STAFF RECOMMENDATION

NCPC File No. 6979

DISTRICT OF COLUMBIA WORLD WAR I MEMORIAL RESTORATION AND REHABILITATION

September 24, 2009

PROPOSED SITE IMPROVEMENTS

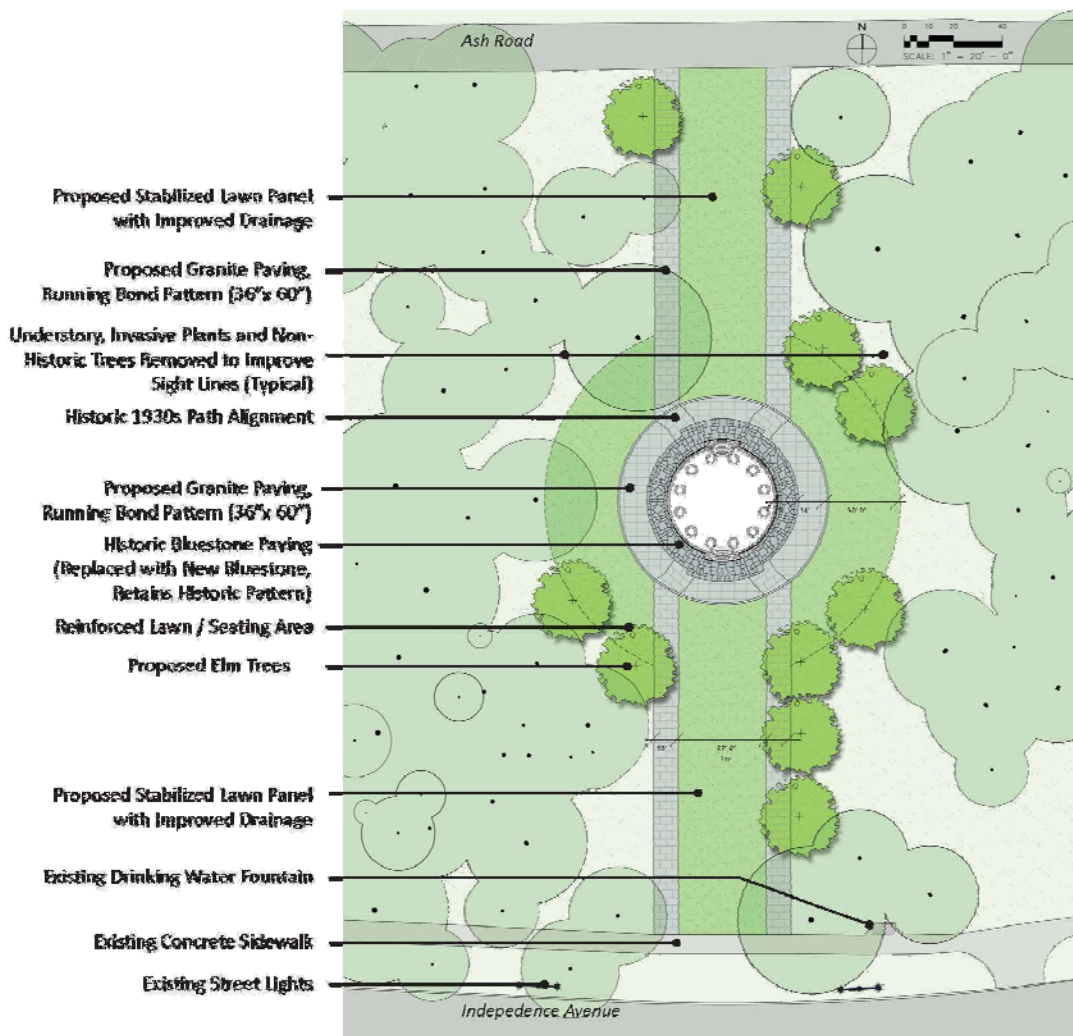
Staff supports the much needed cleaning and repairing of the memorial and supports the use of different materials to distinguish between the historic and non-historic features of the Memorial. Staff commends NPS for undertaking this long awaited and much needed restoration of the DC WWI memorial. Its condition has been noted in recent years by citizens and historic preservation organizations. The D.C. Preservation League has included the memorial on its “most endangered” historic landmarks list in the past.

Viewshed

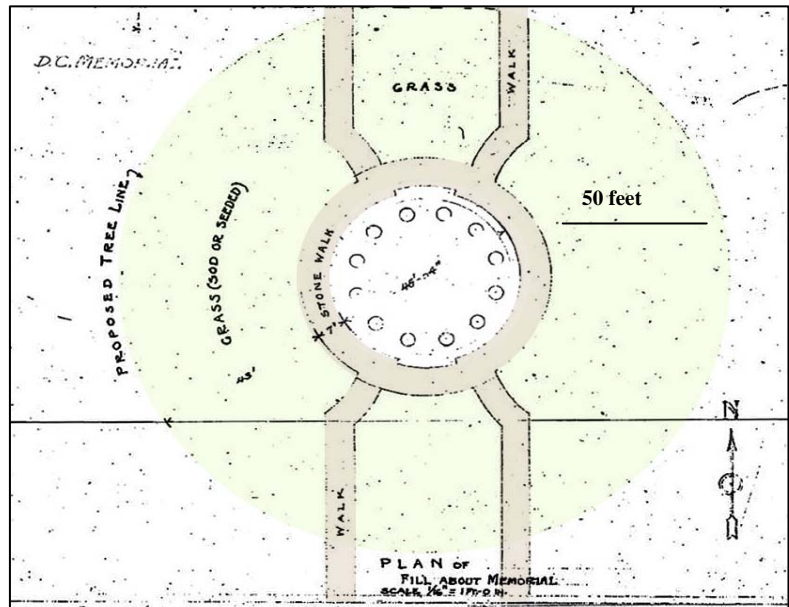
Staff supports the restoration of the historic 50’ open lawn around the memorial and is encouraged that NPS plans on using the Memorial as a bandstand again. The restoration of the

open lawn will restore vistas to and from the Memorial and allow space for people to gather to watch the bands.
